FCC Class II Permissive Change for FCC ID: ZNFHBS-XL7

This is to request a Class II permissive change for FCC ID: ZNFHBS-XL7 , originally granted on May 22, 2019
The device is identical to the previously certified LG STEREO Headset except for the modification following:

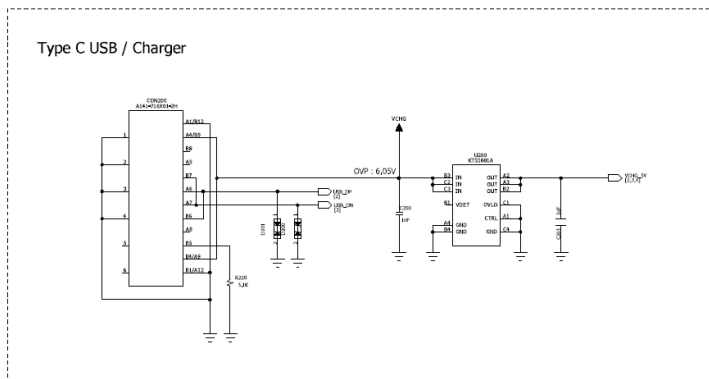
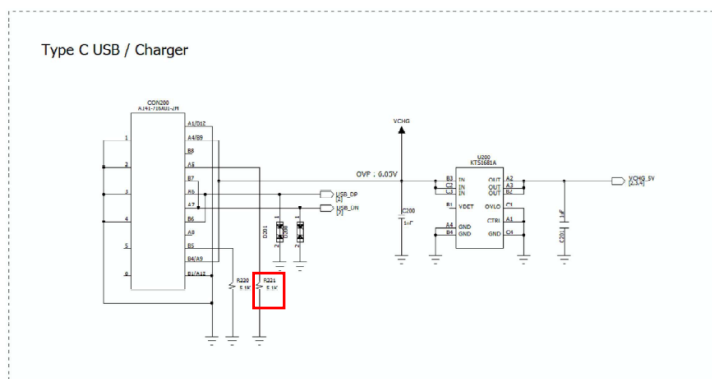
- Add Pull down resistor(R221, 5.1K) to improve reverse charging on TYPE-C adapters. Please refer below shcematics.

Before modification)

After modification)
